# Technical Service Bulletin

June 16, 2023

## Rotel Bluetooth 5.1 aptX™ HD Module

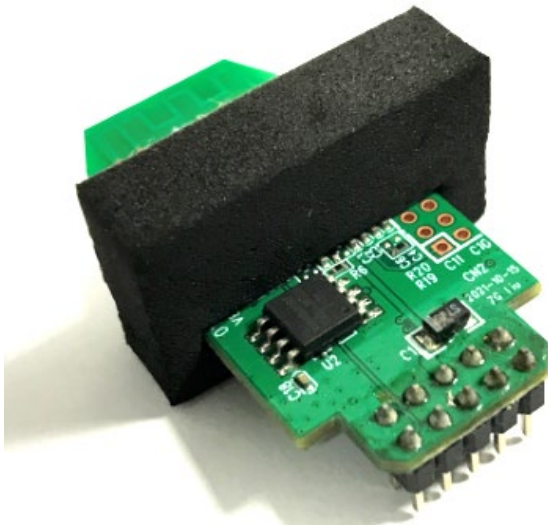
● New Bluetooth module 5.1 built Qualcomm IC as below photo.
